## CMB Meeting Minutes #147

REFERENCE Project No. M544.1, Contract No. 149 Task 1-8.02

SUBJECT: Configuration Management Board Meeting # 147 – Rev. No. 0

\\sv6nas03\m544\1\FinalDesign\DRAWINGS\CS155-2\1254\SHEET FILES\02\_CIVIL\09\_WATER DISTRIBUTION\12540209WD206.dwg  
 fboyani Fri Dec 02, 2011 - 5:59 pm WD-206

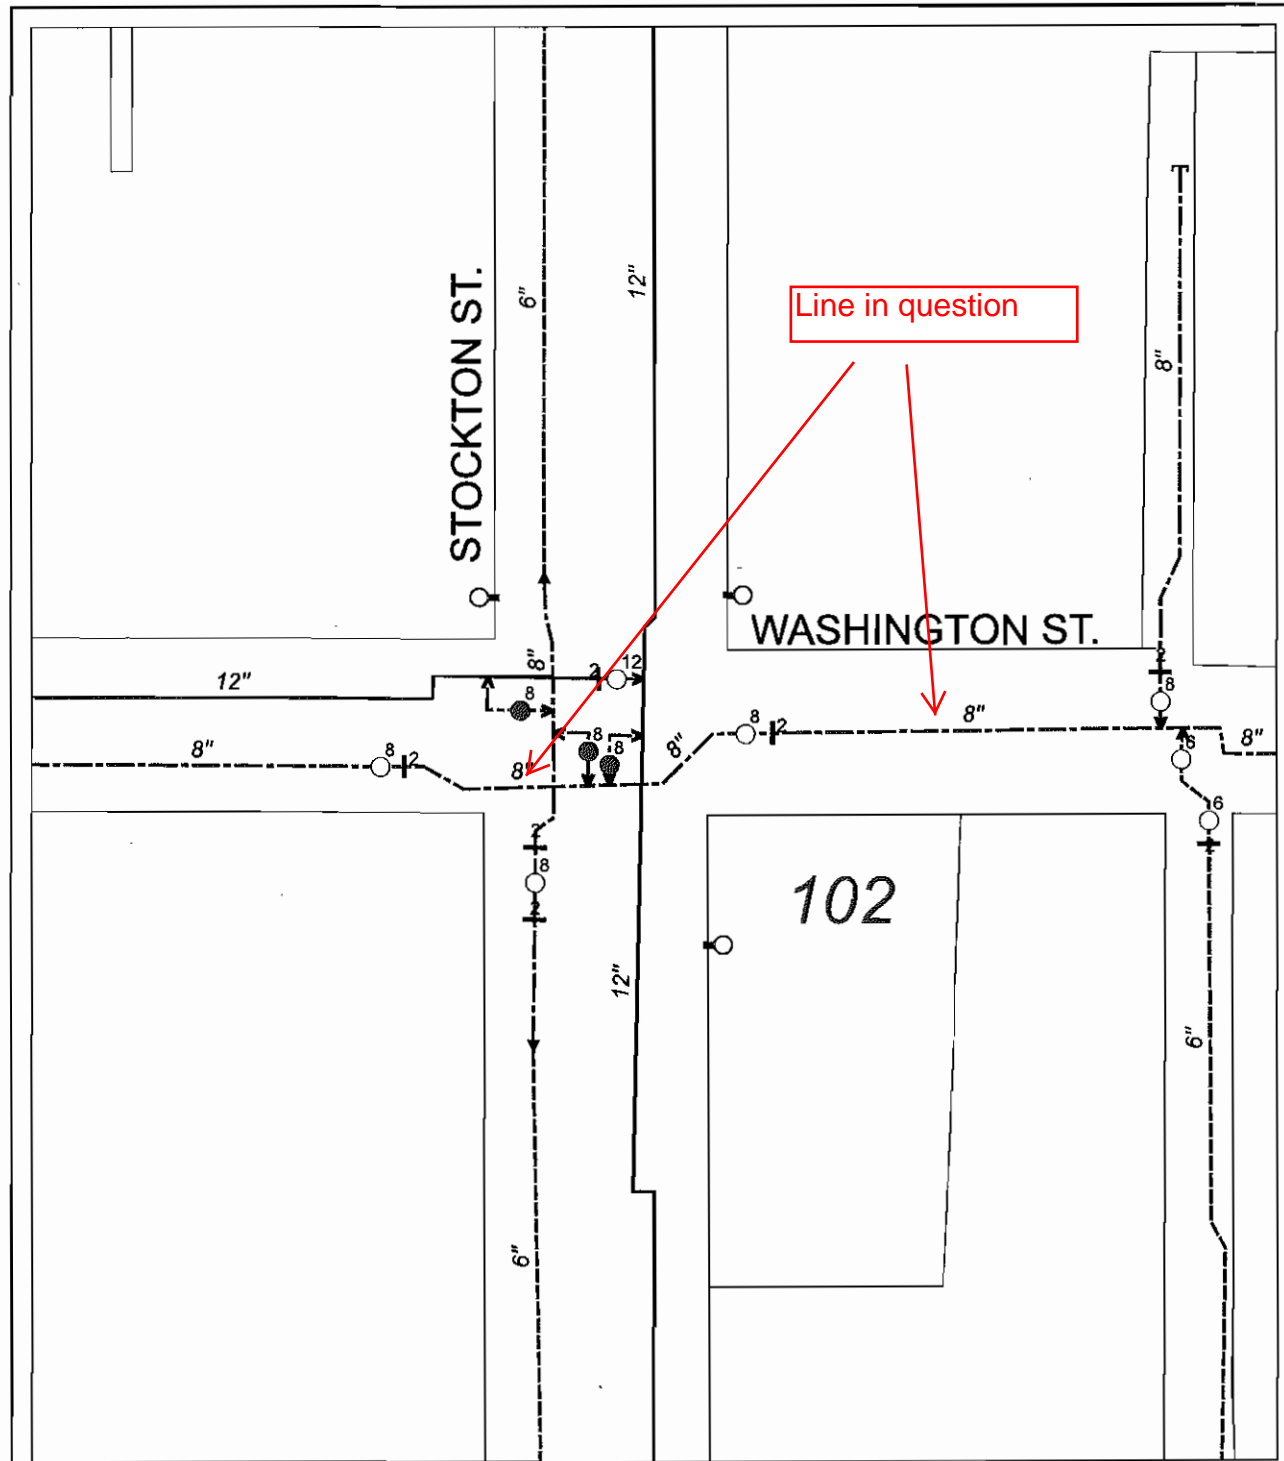
The scope of work is as follows on drawing WD-206:

- A. Delete installation of offsets on 8" line WAS 11+14+-, just install the gate valve and cap with thrust block. Install offsets as needed when the 8" line is installed over the completed station roof, a year or so down the line.
- B. Delete installation of offsets on 12" line WAS 11+13+-, just install the gate valve and cap with thrust block. Install offsets as needed when the 8" line is installed over the completed station roof, a year or so down the line.
- C. CDD will install a 8" gate valve in it at the time of installation.
